File Number	PLPR-2408-0001		Contact	Jason Mozol, jmozol@duluthmn.gov	
Type	MU-C Planning Review		Planning Commission Date	October 8, 2024	
Deadline for Action	Application Date	August 28, 2024	60 Days	October 28, 2024	
	Date Extension Letter Mailed	October 2, 2024	120 Days	December 26, 2024	
Location of Subject	West Arrowhead Rd				
Applicant	Force 1 LLC		Contact	Jesse Carlson	
Agent	Titanium Partners		Contact		
Legal Description	010-1773-00020				
Site Visit Date	September 18, 2024		Sign Notice Date	September 24, 2024	
Neighbor Letter Date	September 19, 2024		Number of Letters Sent	7

Proposal

The applicant is proposing a new 4,000 square foot dental clinic on West Arrowhead Rd in a MU-C district. This project is phase 2 of Titanium's development of this site that included Bell Bank's new location completed earlier this year, which is adjacent to the dental clinic lot.

DENTIST OFFICE
DULUTH, MN

4 NORTH ELEVATION
3/16" = 1'-0"

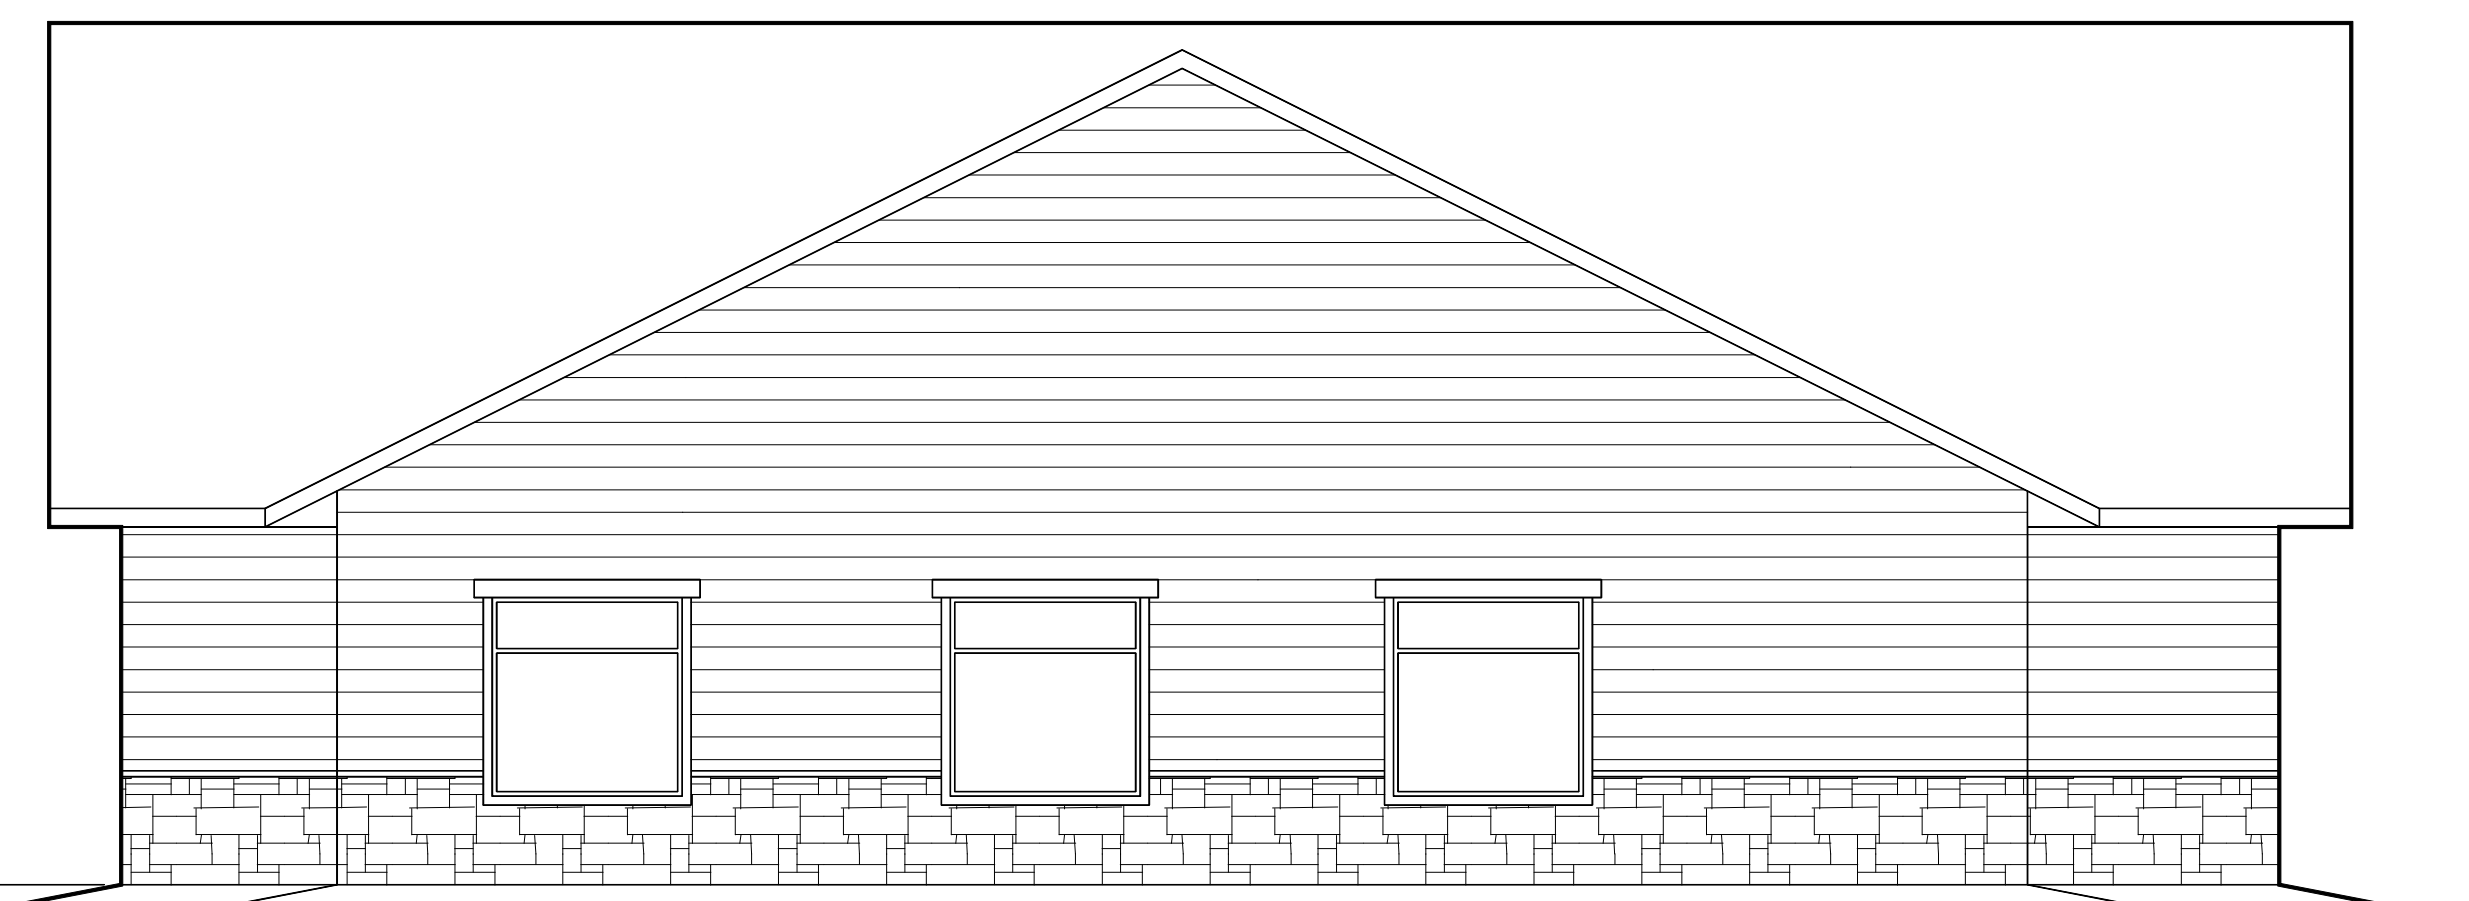
7. Sec. 50-29 (Sustainability Standards). Does not apply because the structure is under 10,000 square feet.
8. Sec. 50-30 (Building Design Standards). The proposed structure meets these requirements for transparency, roof articulation, and entryway design.

SITE LIGHTING CALC.

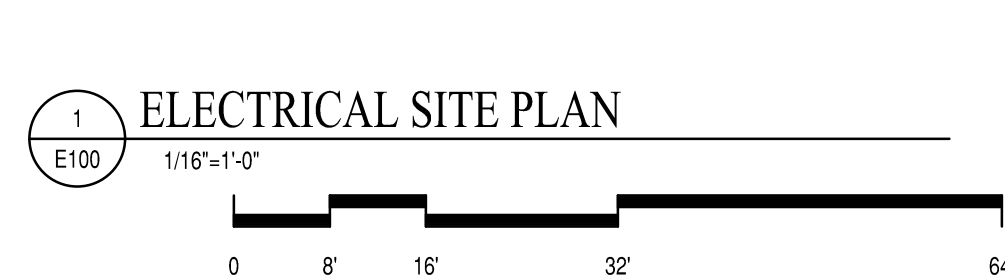
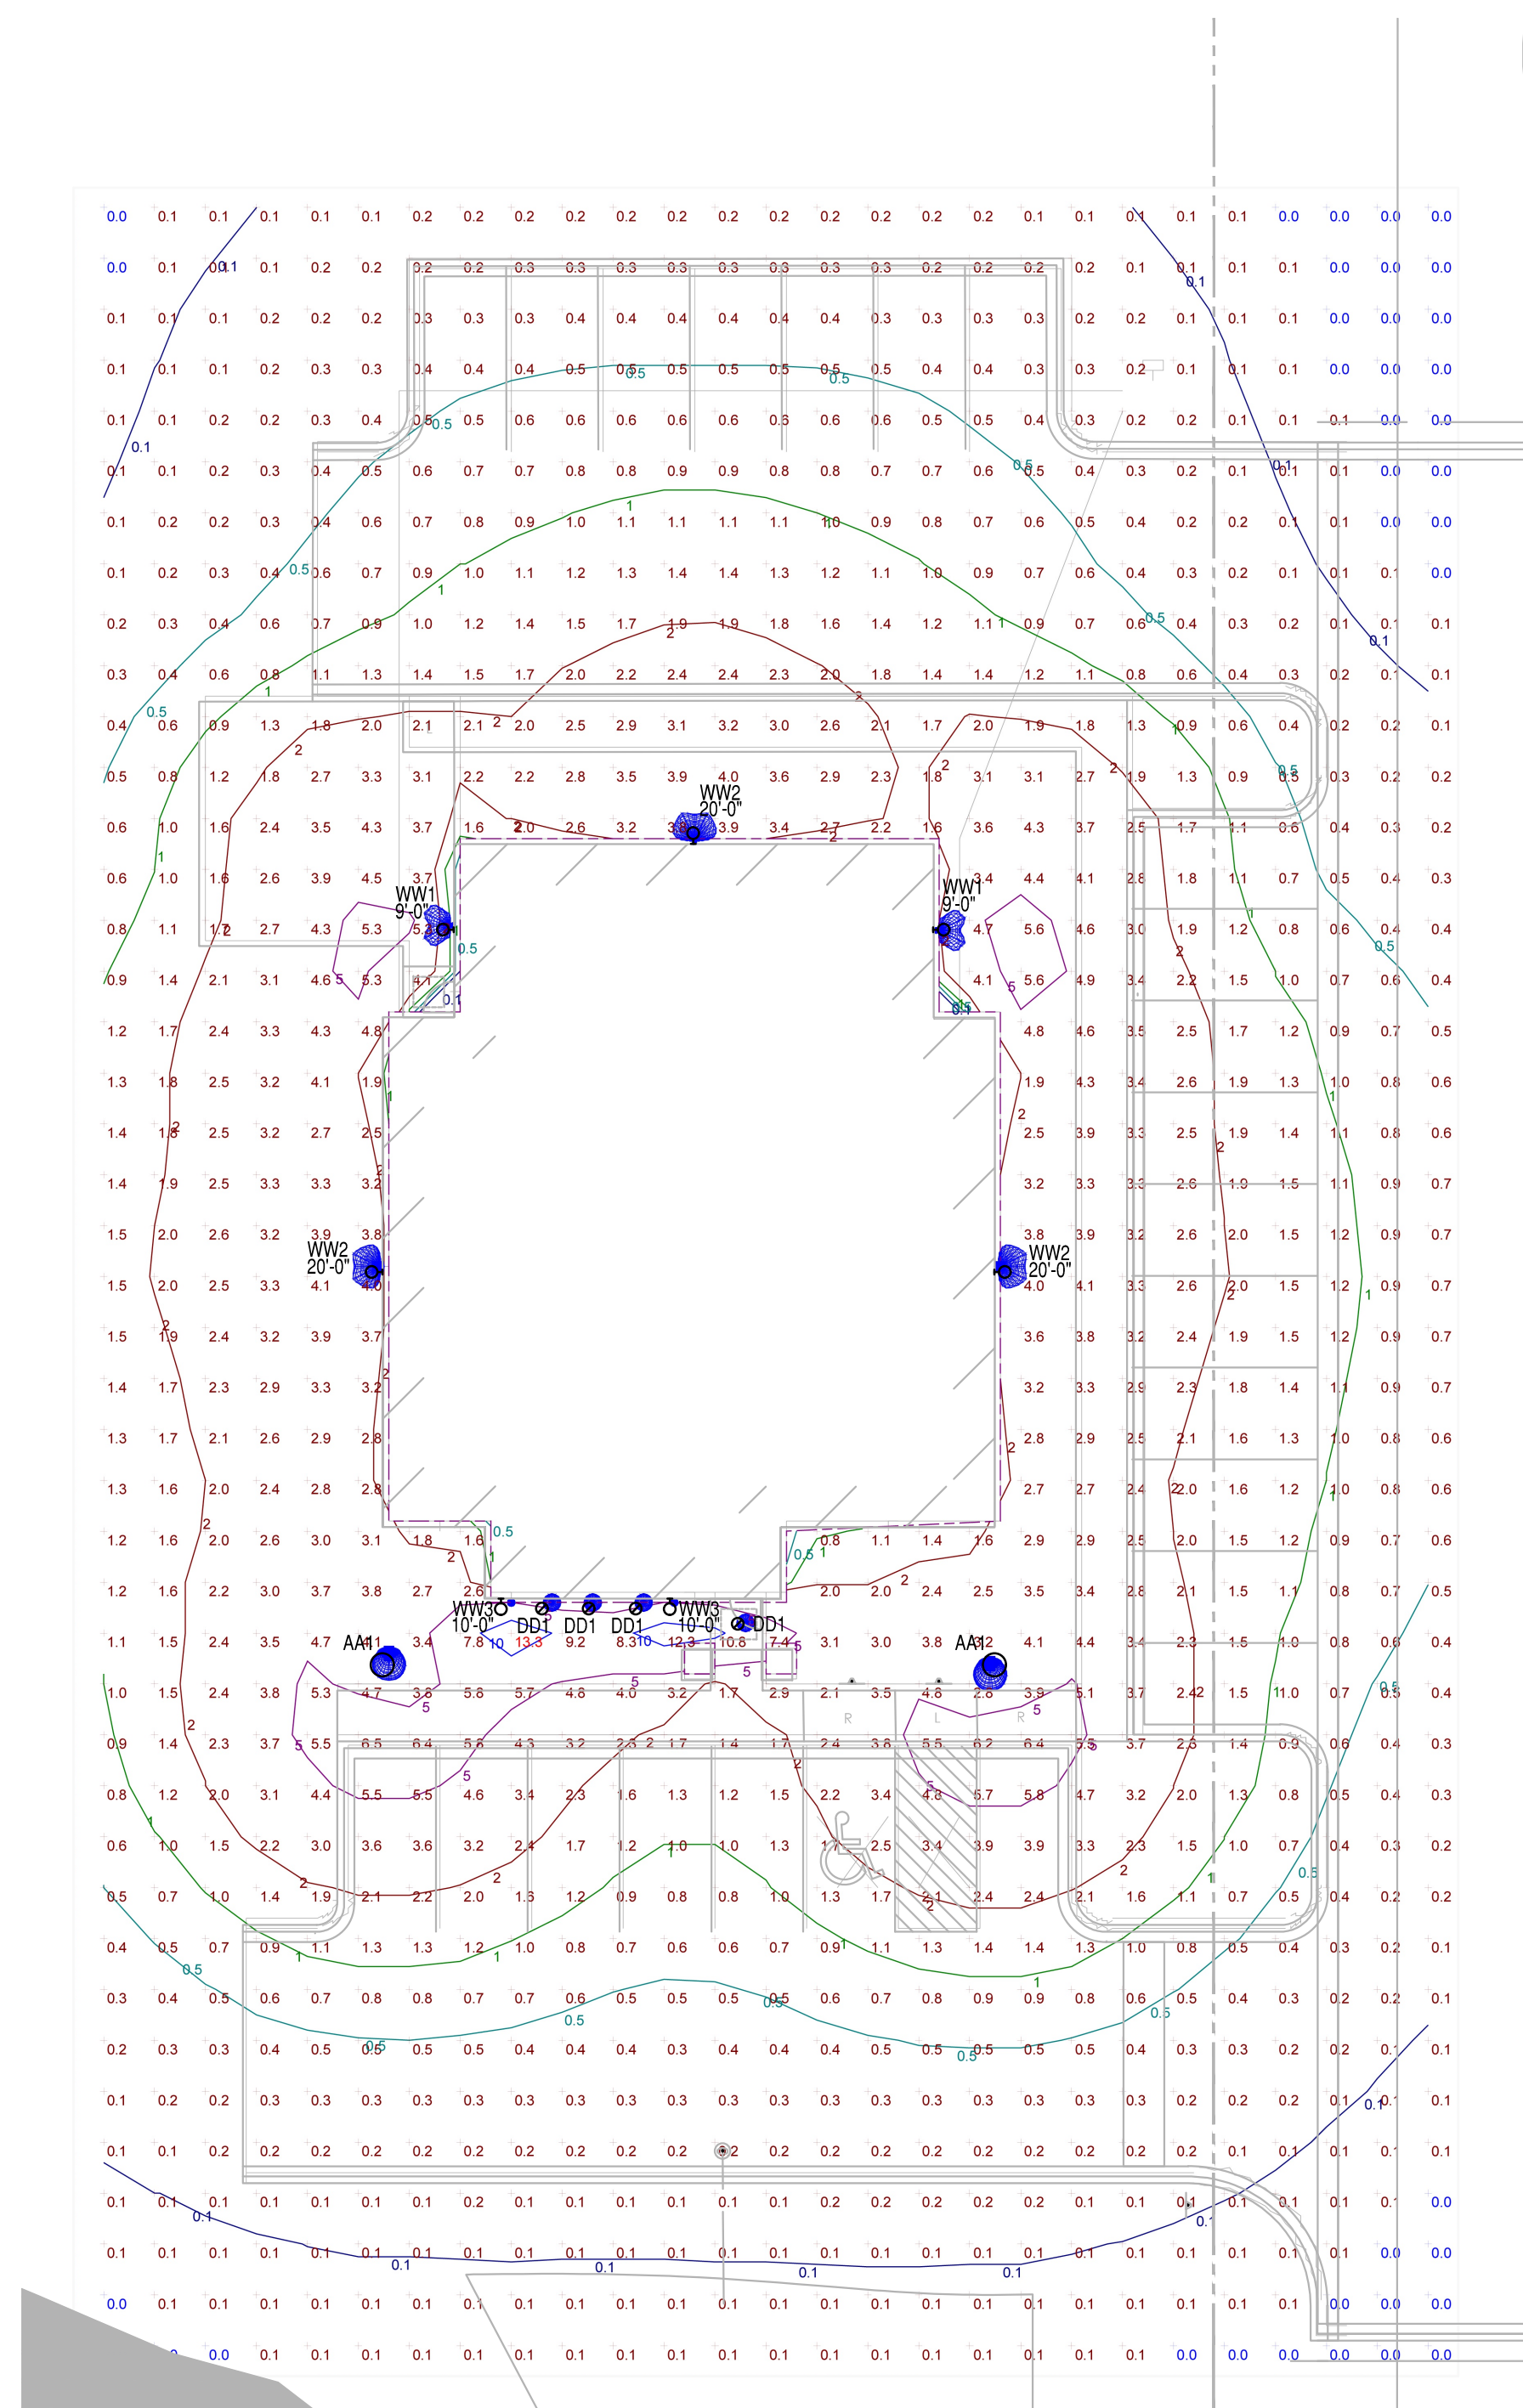
9. Sec. 50-31 (Exterior Lighting). Exterior lights will be installed on the outside of the structure and along the front sidewalk. A photometric plan and light fixture designs were provided that demonstrate lights that limit trespass and provide downcast, compliant lighting.
